Celebrity® Single Bowl Sink Model GECR2521 Series – A.D.A. Compliant

Shop Drawing Submittal Review

Project Name: Webster University-**ISB**

SPEC SECTION: 22 4216.16
Commercial Sinks

SK-1

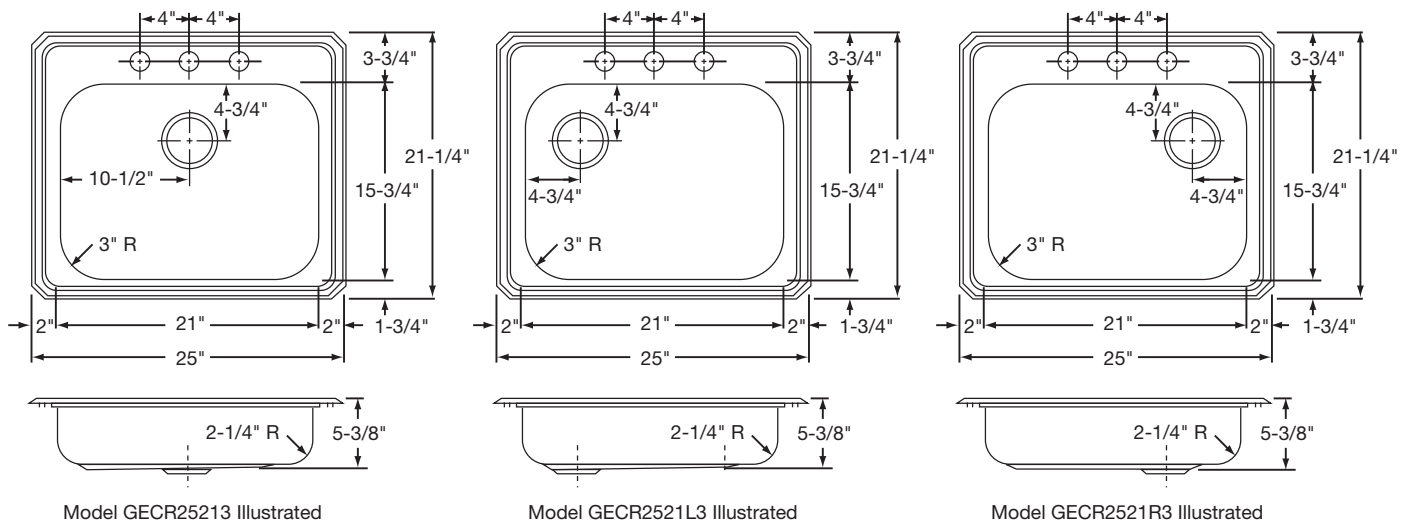
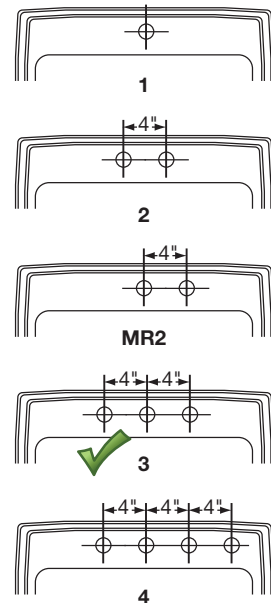
1. Provide under counter waste and supply protective piping covers as required.
Verify requirements with the architectural drawings.
2. Escutcheons are specified to be cast brass. Refer to specification section 220518.

X					P-Trap Proflo Model PFPTB403	
X					Angle Stops BrassCraft Model SCR19XC	
X					Supply risers BrassCraft Model 1-12A C	
	X				Escutcheons Proflo Model PFE7	Escutcheons are specified to be cast brass. Refer to specification section 220518.
Sink SK-1						
X					Fixture Elkay Model GECR2521	
X					Faucet Chicago Faucet Model 200-AABCP	
X					Outlet Waste Disposer Kit Proflo Model PFEWB200	Provide under counter waste and supply protective piping covers as required. Verify requirements with the architectural drawings.
X					P-Trap Proflo Model PFPTB403	
X					Angle Stops BrassCraft Model SCR19XC	
X					Supply Risers BrassCraft Model 1-12AC	
	X				Escutcheons Proflo Model PFE7	Escutcheons are specified to be cast brass. Refer to specification section 220518.
Garbage Disposer GD-1						
X					Fixture Emmerson In-Sink-Erator Model Evolution Compact	
Sink SK-2						
X					Fixture Elkay Model LRAD1517	
X					Faucet Chicago Faucet Model 895-317GN2AE29ABCP
